PLANNING BOARD AGENDA
August 19, 2025 – 6:00 p.m.
City Council Chambers, 60 Court Street

- a. **45 Flightline Drive: UPS Temporary Overflow Parking Lot:** The Planning Board will hold a PUBLIC HEARING, review, and act on a Site Plan Review and Special Exception application submitted by Wentworth Partners & Associates on behalf of UPS and Marc Blais General Contractor, Inc. to establish a temporary gravel overflow parking lot to support UPS peak seasonal demand. The site is located at 45 Flightline Drive (Parcel ID 131-007) within the Industrial zoning district and is subject to Chapter 60, Article XVI, Division 2 – Site Plan Review and Division 3 – Special Exception.

Re: **Application for Site Plan Review**
Temporary Overflow Parking Lot
45 Flightline Drive
Auburn, ME 04210

PROPOSED SITE PLAN 1
SCALE: 1" = 30' C100

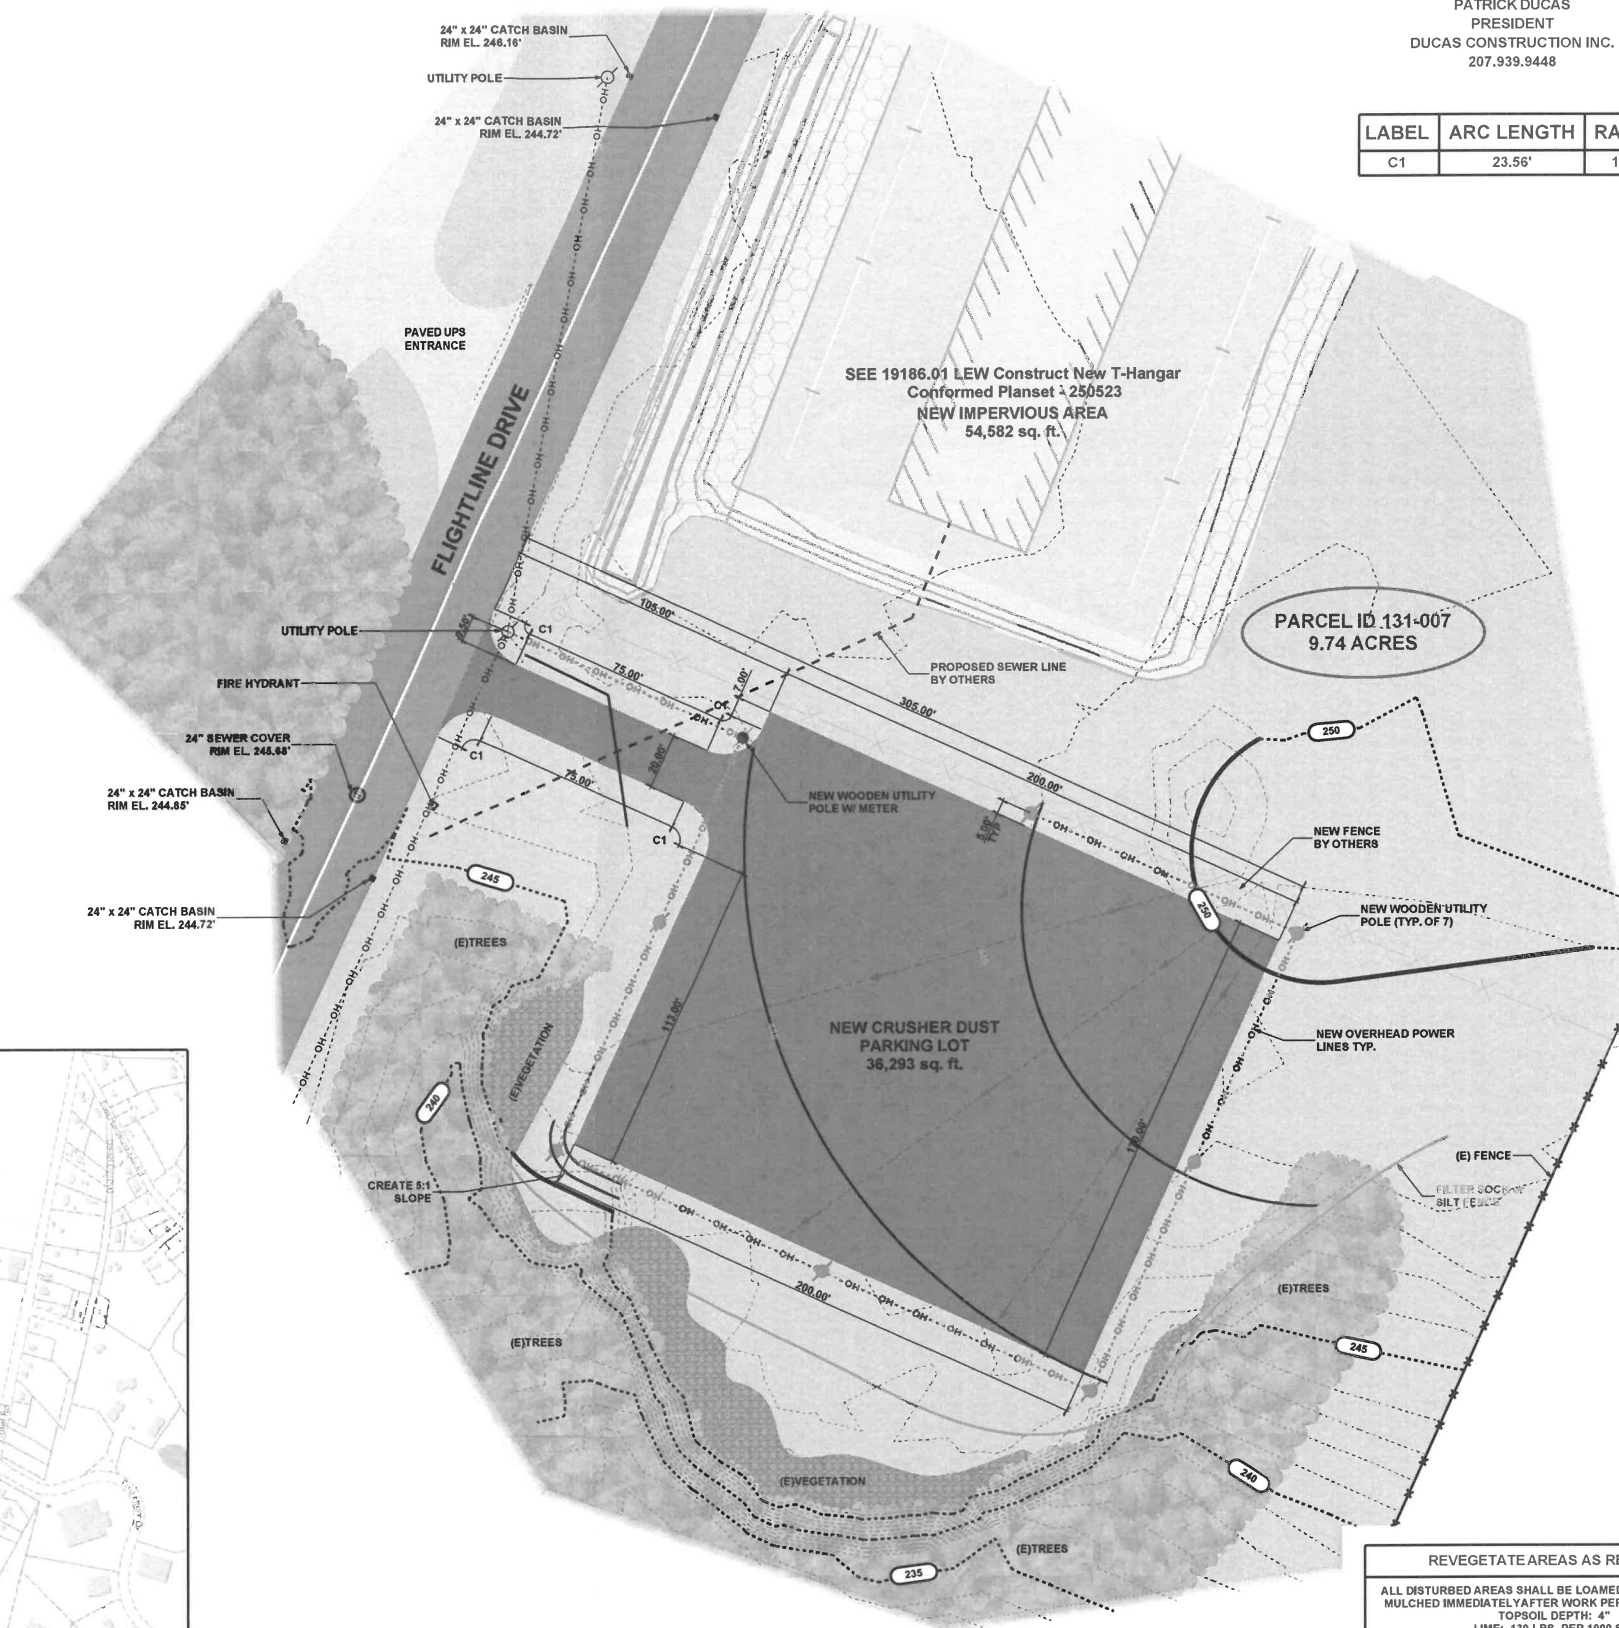
- *Gravel is noted, but staff recommends addressing erosion and stabilization. Alternatives such as reclaim should be evaluated and BMPs specified in your plan. Engineering is still recommending that the parking lot be paved, and gravel will only be allowed at the discretion of the Planning Board.*

- *Please confirm whether any lighting is proposed. If so, a basic lighting plan must be provided.*
-

A. This application is seeking to replace an existing gravel parking lot on the same property with a two-year temporary seasonal use parking area. Erosion and stabilization are addressed on the Construction Plans sheets C000 and C100 as well as with the specific material callout. Furthermore, the use of any petroleum-based materials for this application completely contradicts the intentions of part 2 above.

A. A basic lighting plan is part of this submittal, specifying the light fixture and spacing.

Approved Site Plan

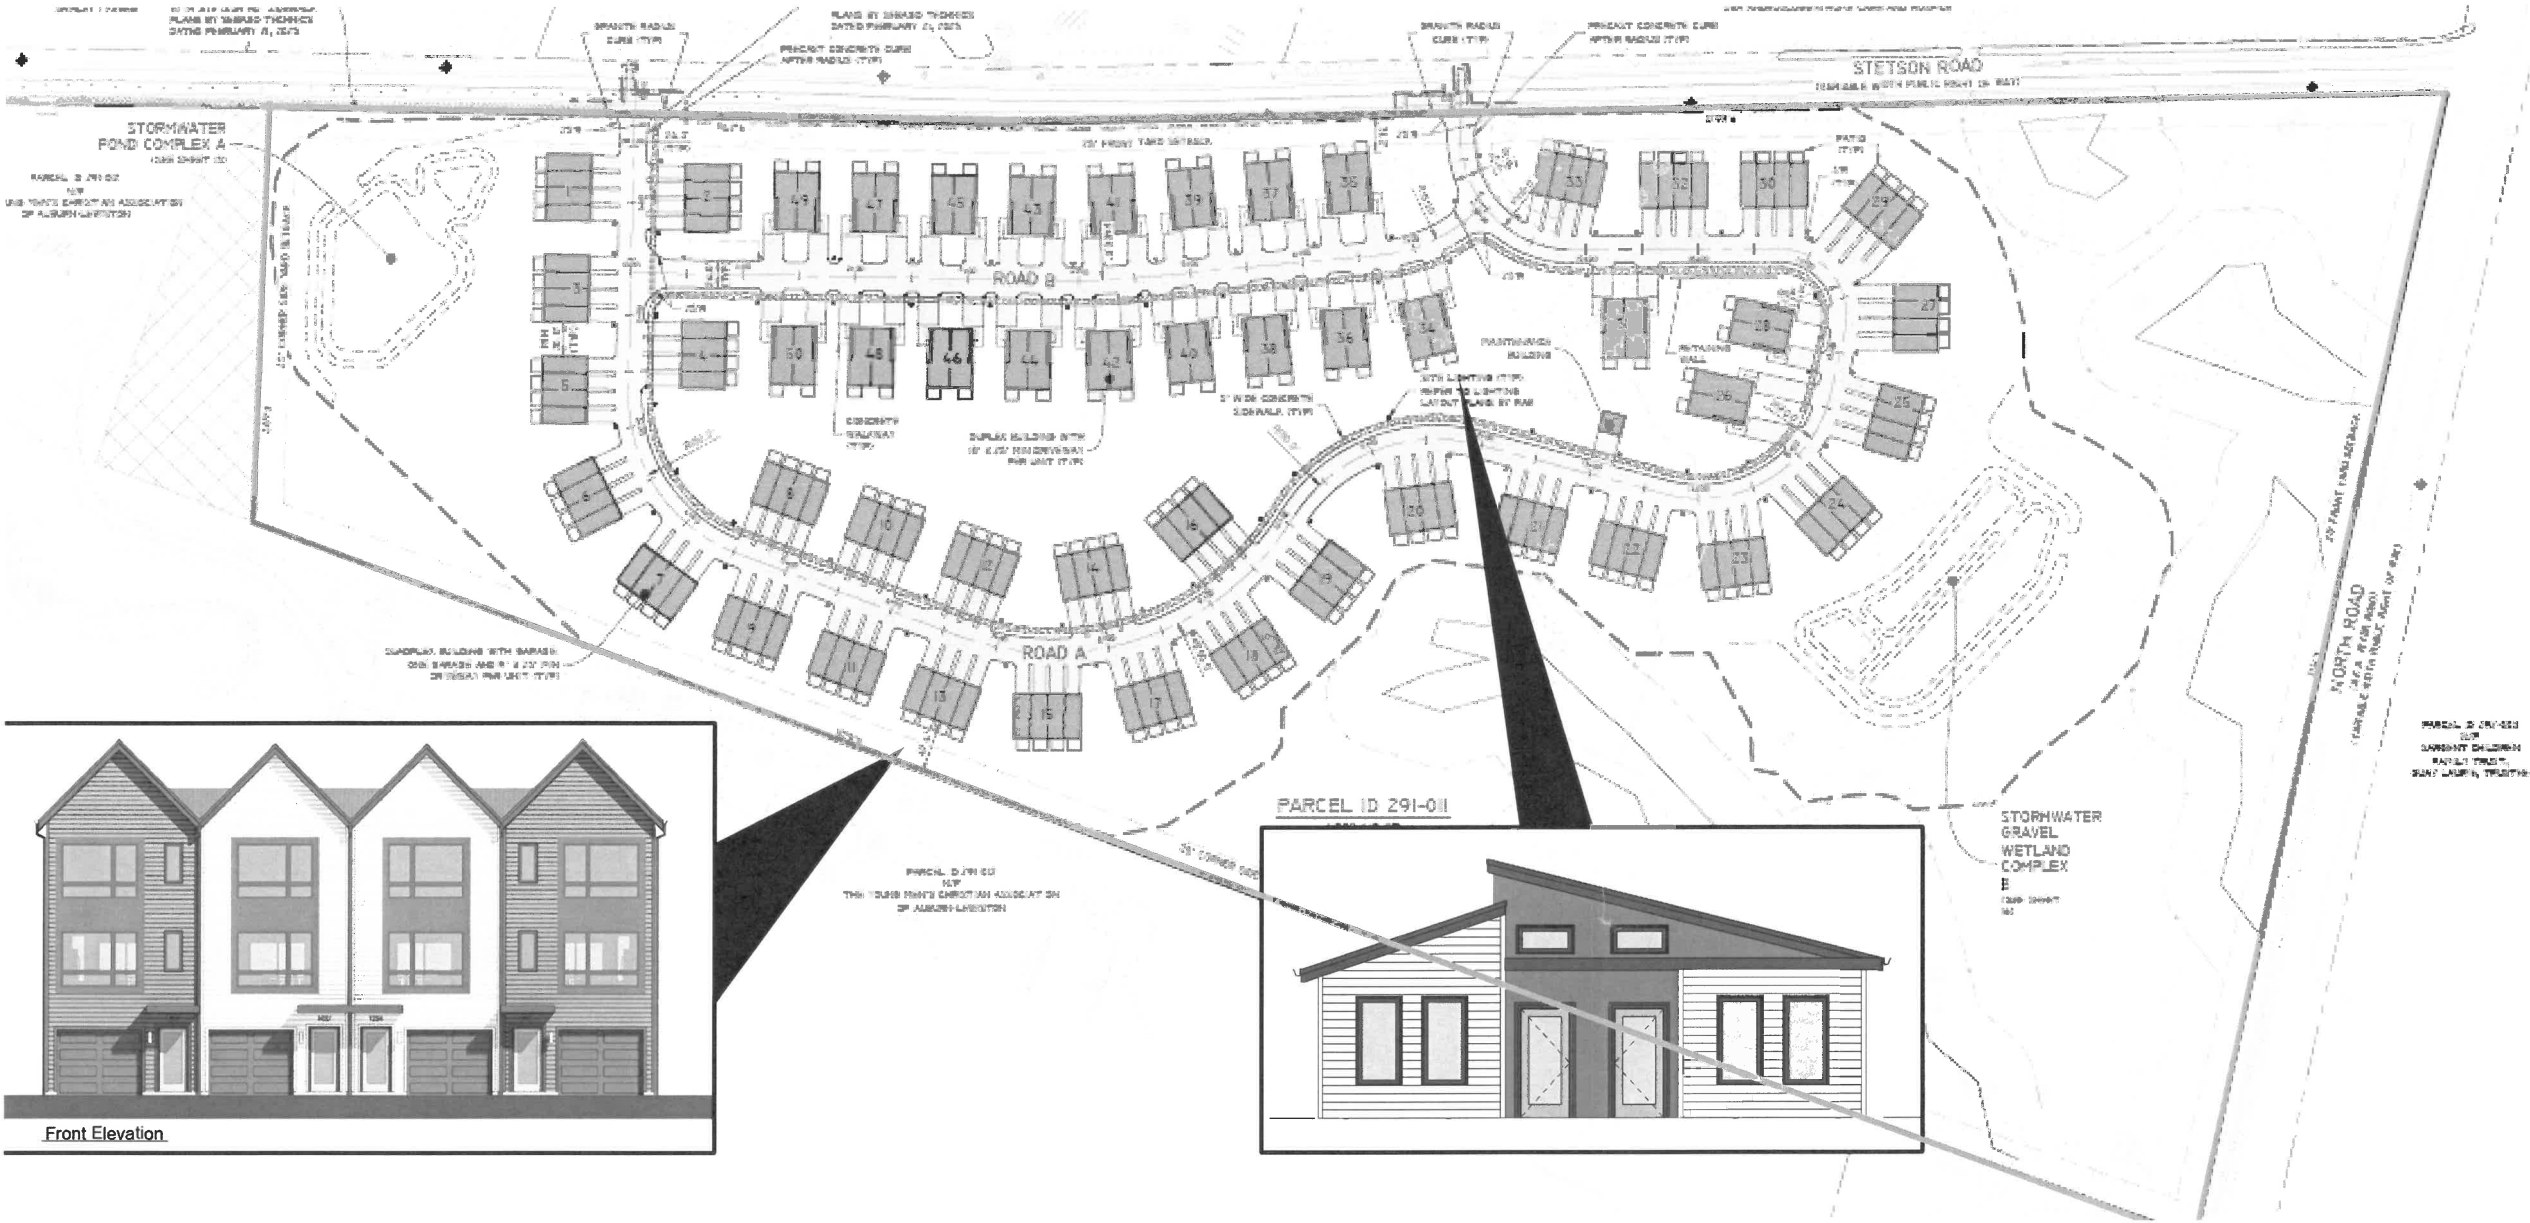
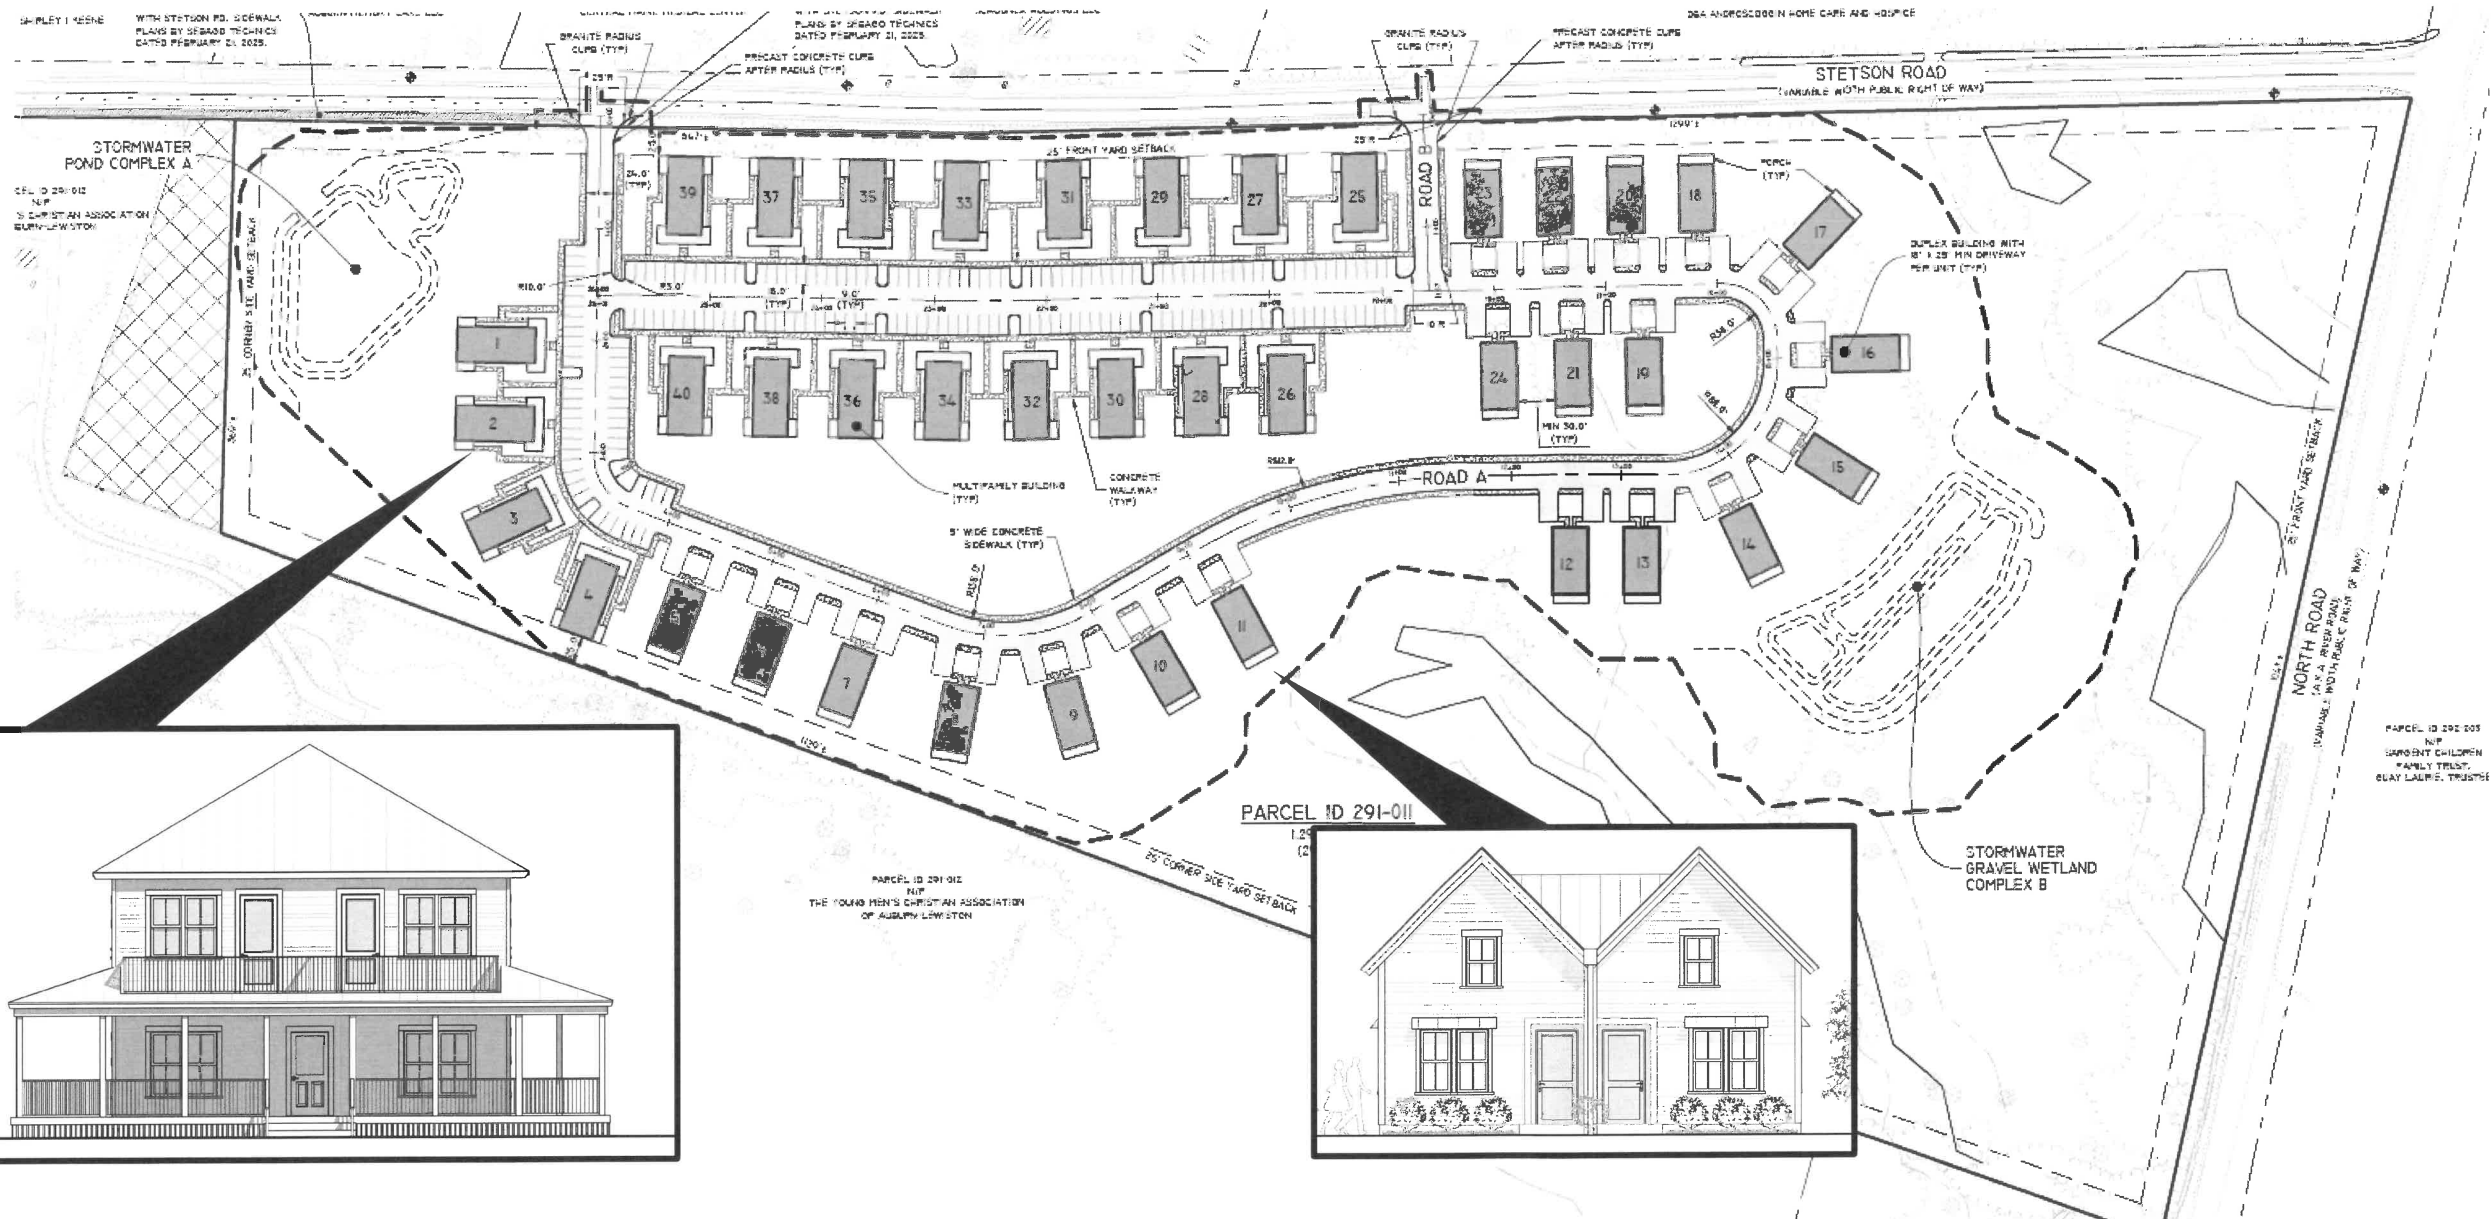
Re: A.R. Building Stetson Road Development, proposed modification and conceptual architecture

Staff recently met with representatives from A.R. Building Co. regarding their Stetson Road Development to discuss modifications to the site plan and structures. Since the proposed changes do not increase the project's scope in terms of impervious area or the number of units, Sec. 60-45 allows staff to approve the changes. However, both staff and the applicant wanted to provide the Board with an update and offer an opportunity to share any thoughts or concerns.

- 160 Units
- 20 Duplexes (40 Units)
- 30 Quadplexes (120 units)

- 20 Duplexes (40 Units)
- 20 Six Units (120 units)
